## **MIDWEST POOLED FUND PROGRAM**

### **Progress Report - Third Quarter 2010 July 1<sup>st</sup> to September 30<sup>th</sup>**

Midwest Roadside Safety Facility  
Nebraska Transportation Center  
University of Nebraska-Lincoln

## **Pooled Fund Consulting Summary**

Figure 2. BD-615M

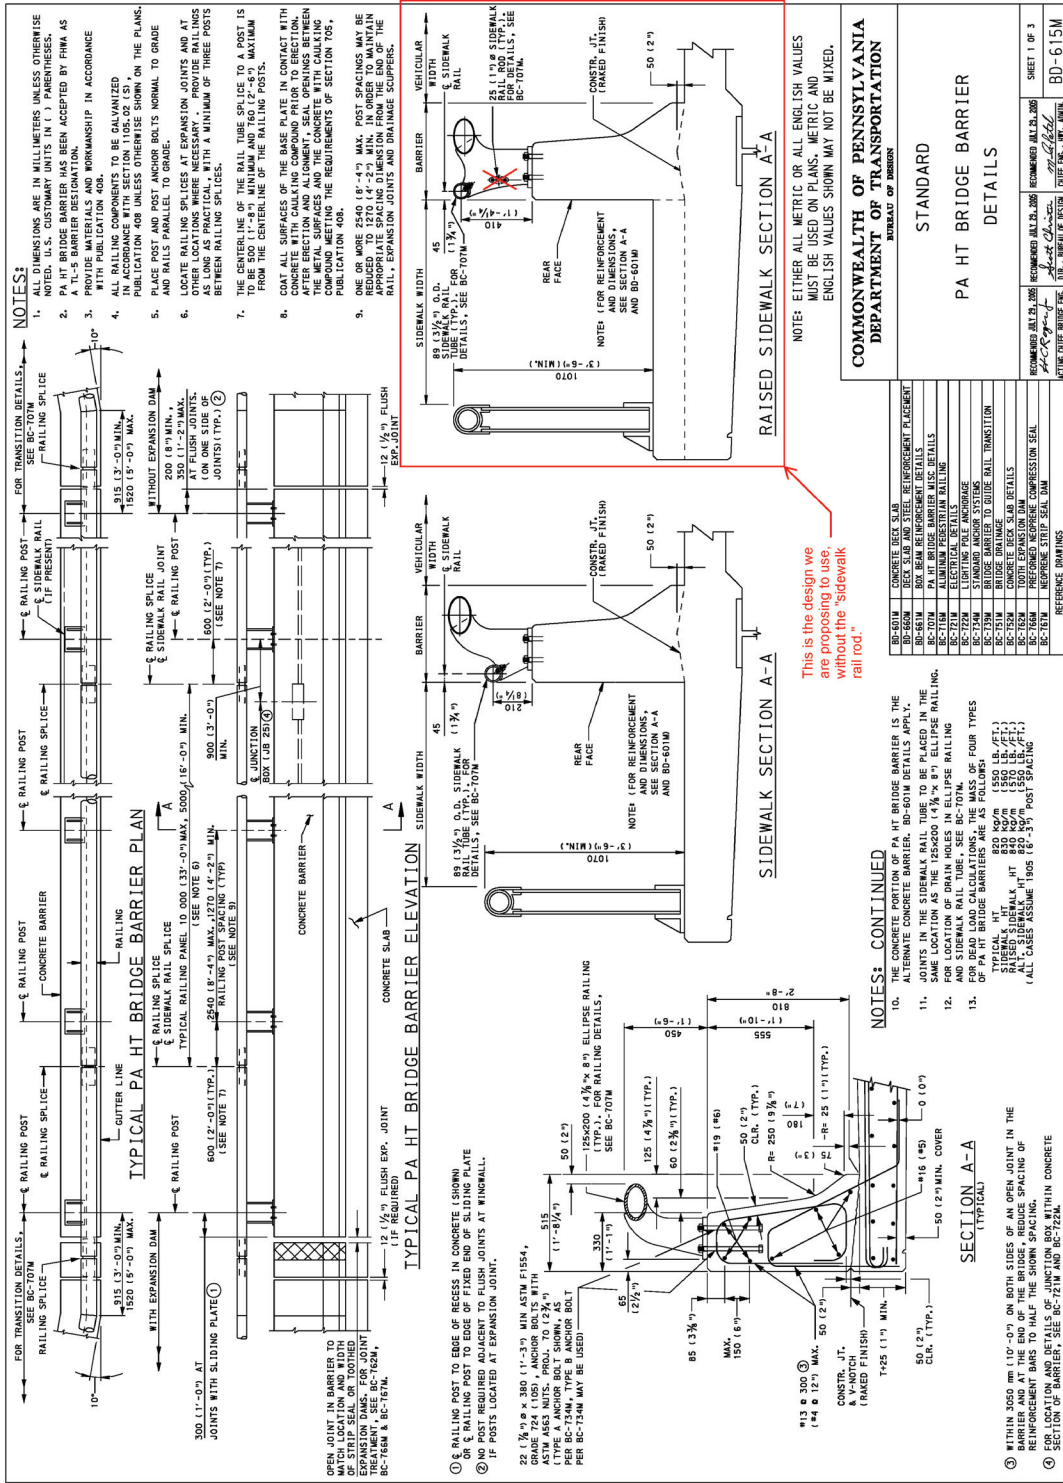
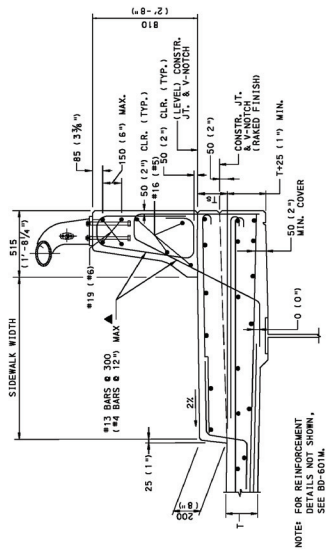
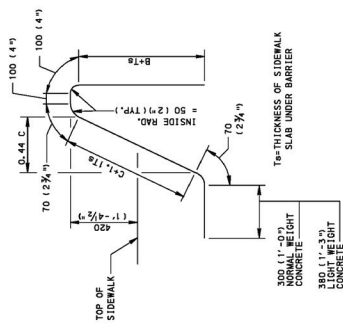
Iowa DOT is currently working with Illinois DOT in detailing a bridge rail for the new I-74 bridge. The bridge will accommodate a multi-use trail behind the rail on one side of the bridge. For this application, we are considering using the Pennsylvania HT rail with a supplemental “sidewalk rail tube” attachment, as detailed in Pennsylvania’s standard drawings (attached).

It is our understanding that the modified post used to support this rail has not been crash tested. Therefore, we request your assistance in assessing the effect, if any, the modified post and sidewalk rail tube would have on the crashworthiness of this rail configuration, and whether the presence of the sidewalk rail tube in a TL-5 impact could produce flying debris.

Note that we are interested solely in the use of the design shown in the “raised sidewalk section A-A” on sheet 1 of 3 of BD-615M. Also note that we will not be using the “sidewalk rail rod” or any of its associated hardware.

Figure 9.

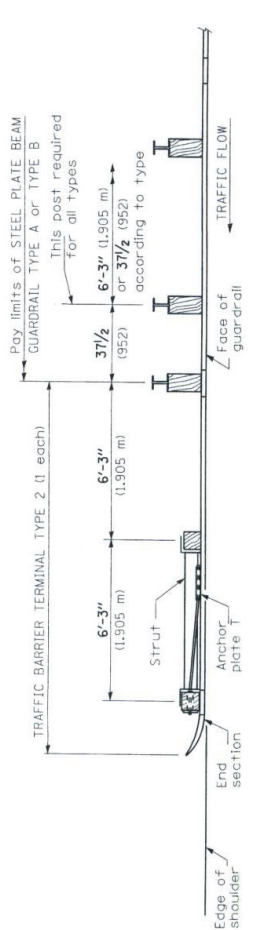
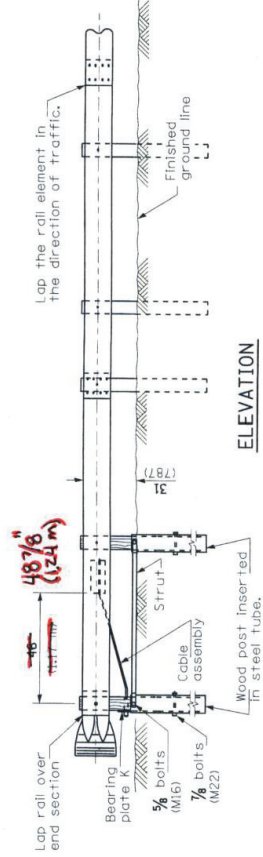
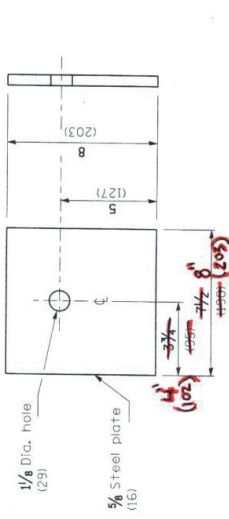
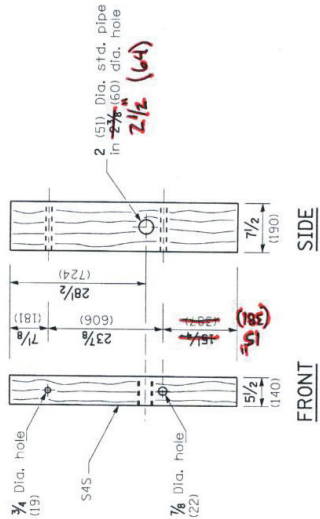
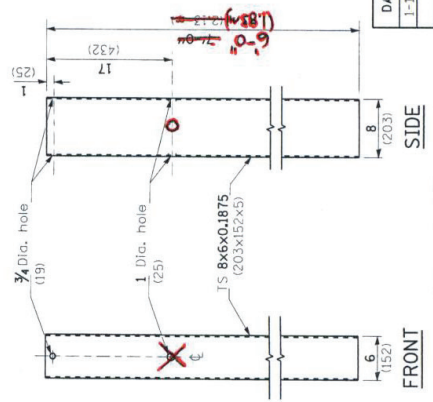
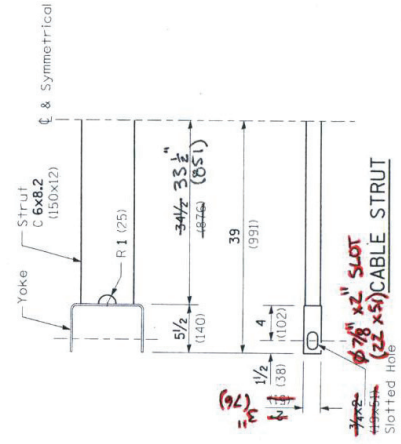
We'd welcome any opinion or observations on using this for anchoring the downstream end of guardrails. Per one of our earlier discussions with you or Karla, we do plan to correct the length of the soil tube to 6' from the 7' shown.

I am enclosing a pdf file which compares your downstream anchor hardware to that currently used by MwRSF. Within the file, corrections are noted that show which dimensions are actually used within our CAD details. For our general guardrail testing programs, we utilize a standard end anchorage system on both the upstream and downstream ends of our 175-ft long W-beam guardrail installations when terminals are not being evaluated. These anchorages were adapted from the modified BCT, also consider the MGS rail height and cable anchor increased rise, and include a channel strut, two lengthened foundation tubes, and a common cable anchor with bolted attachment plate and bearing plate on each end.

In addition, you inquired as to whether the trailing end hardware noted above could be utilized in a double rail or median-type configuration where reverse-direction impacts could not be achieved on the end spoons. In such installations, we believe that this trailing end terminal hardware in combination with the MGS would likely provide sufficient capacity to successfully contain and redirect most passenger vehicles impacting at high speeds and angles. Unfortunately, no full-scale crash testing programs have yet been performed on most trailing end terminal systems.

Using engineering judgment and in the absence of crash testing, we believe that the downstream trailing end terminal hardware, similar to that used at MwRSF and shown herein, could be utilized in a double rail, median-type configuration. However, full-scale crash testing is the only true way to determine the safety performance of the downstream trailing end terminal system. In addition, it should be noted that future testing may provide a basis for modifying our opinions on this issue.

If one were to have significant concerns regarding the potential for small car snag or wedging under the cable anchor, then a slight design change may be considered. First, it may be advantageous to incorporate blockouts with the end posts in foundation tubes, thus allowing a 8-in. lateral shift of the post, strut, and anchor cable. Such a design modification would likely require a longitudinal stagger of the anchor posts combined with a single post installed between the two blockouts. Unfortunately, there are also concerns with this design variation, such as little or no experimental experience, lack of prepared design details, unique loading on anchor posts and foundation tube, and potential for inadequate cable length with the 8-in. lateral shift.

Figure 10. OhDOT PCB Transition Details

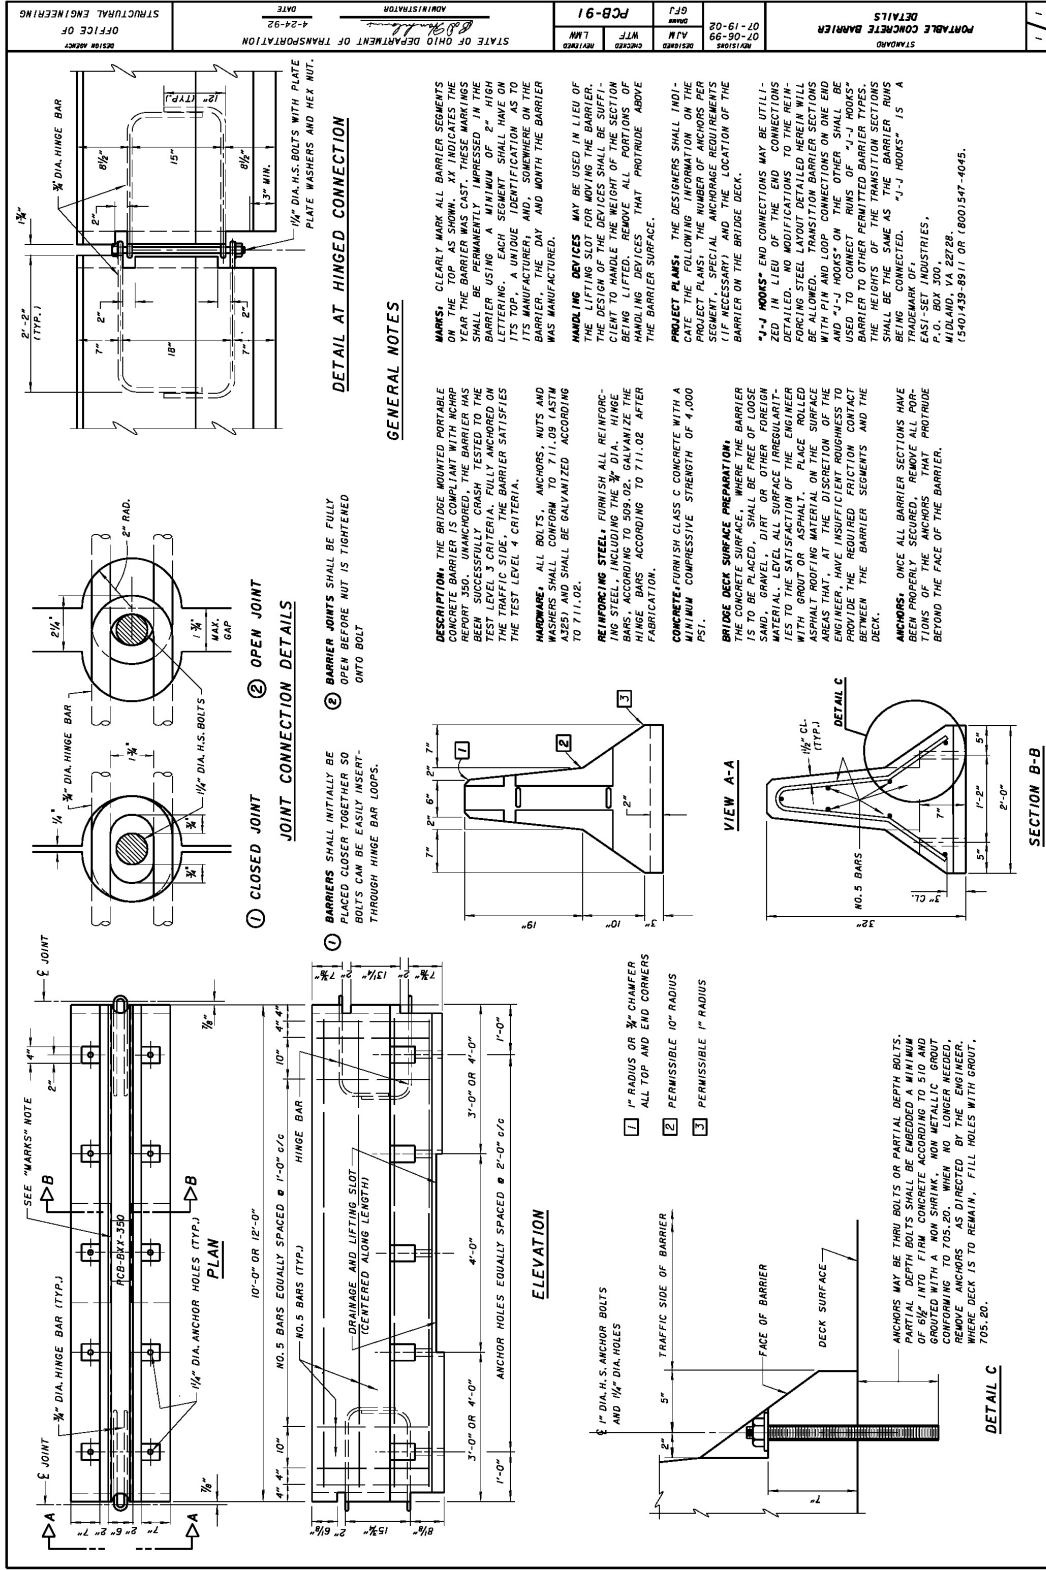
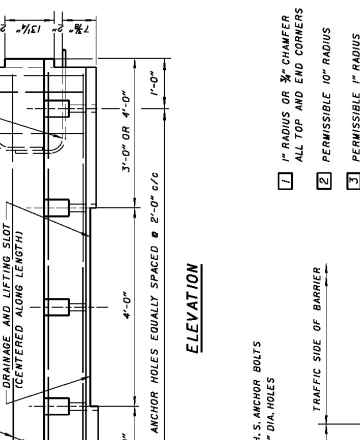
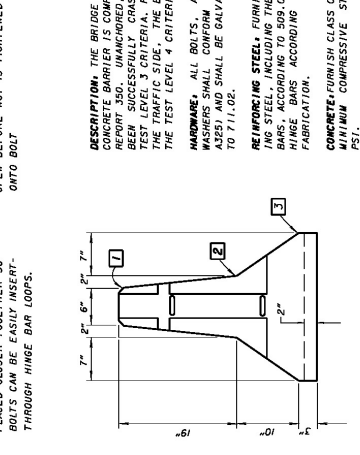
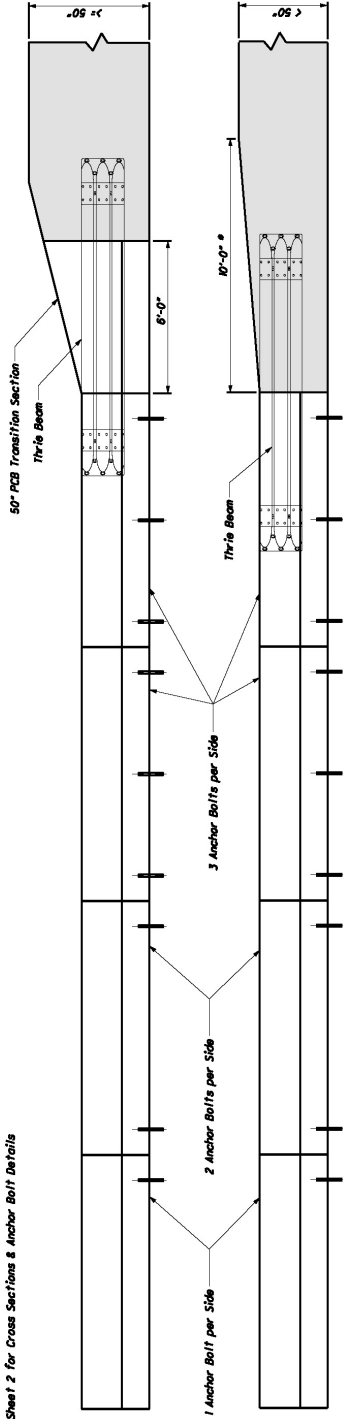
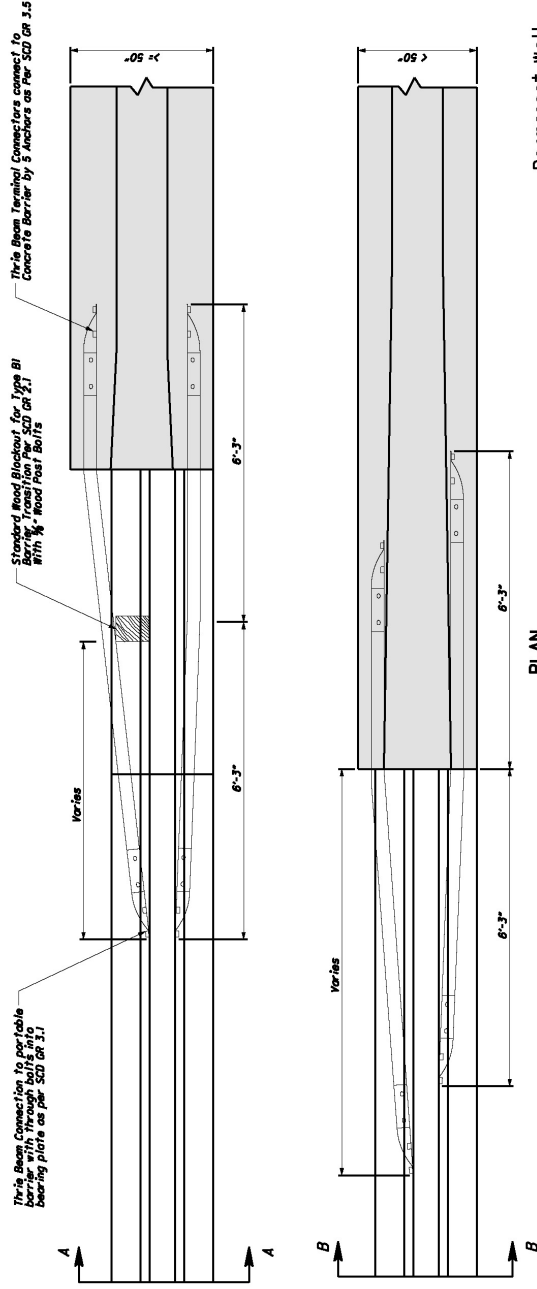
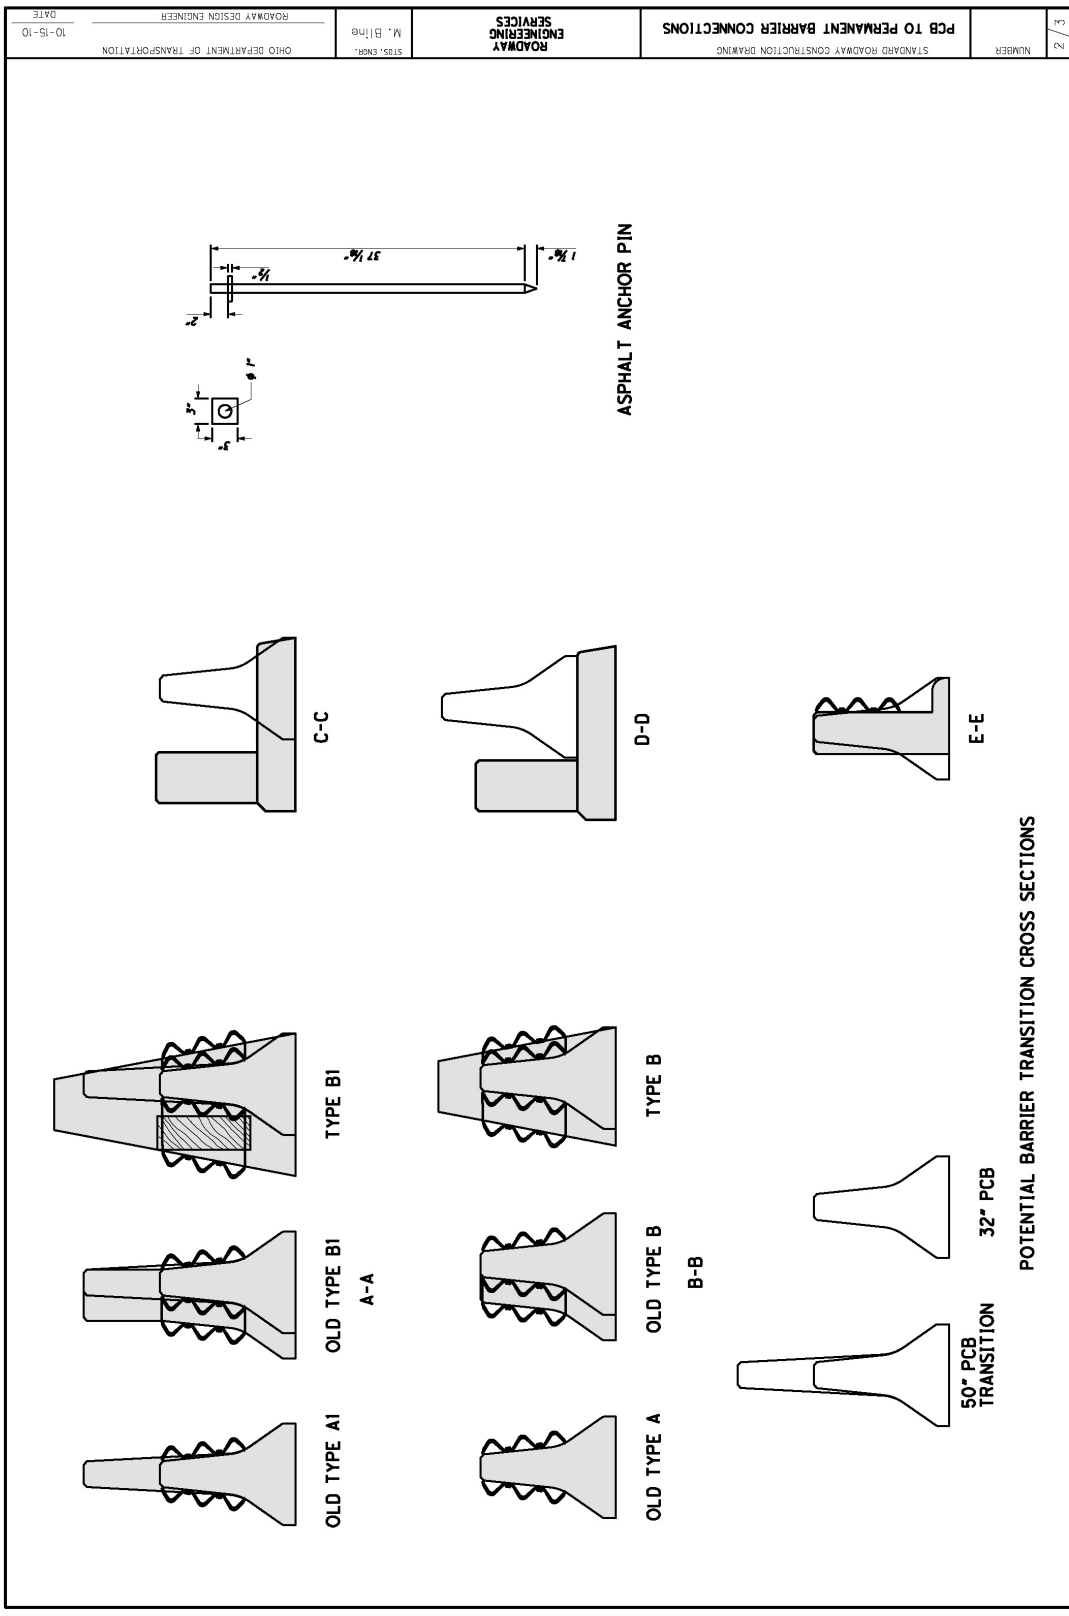
I would appreciate any comments you have on the barrier transition drawing below. There is a need for Ohio to improve the way we are transition from PCB to rigid structures. I have included some pictures from construction projects in Ohio. We know that additional testing is needed but until then we would like to do the best we can. We took the results of the K barrier report and created layouts of our Jersey shaped PCB to different rigid structures. The anchor holes are 1.125" in diameter so we changed the soil anchors to 1" in diameter.

I have gone through the transition plans that you sent and I have a few concerns.

- b. Alignment of the temporary barrier system with the permanent barrier may also change when the transition is applied to different permanent barrier geometries, as shown in below. When attaching to a single-slope barrier profile, the slope break point between the toe of the barrier and the main face of the barrier should be aligned flush with the oncoming traffic side of the single-slope barrier. For safety shape barriers, the toe of the temporary barrier should be aligned flush with the toe of the oncoming traffic side of the median barrier. Vertical median barriers require that the toe of the temporary barrier segments on the reverse direction traffic side be aligned with the base of the permanent barrier on the reverse direction traffic side. These alignments will prevent vehicle snag for oncoming traffic on the permanent median barrier while preventing snag on the toe of the barrier for reverse direction impacts.
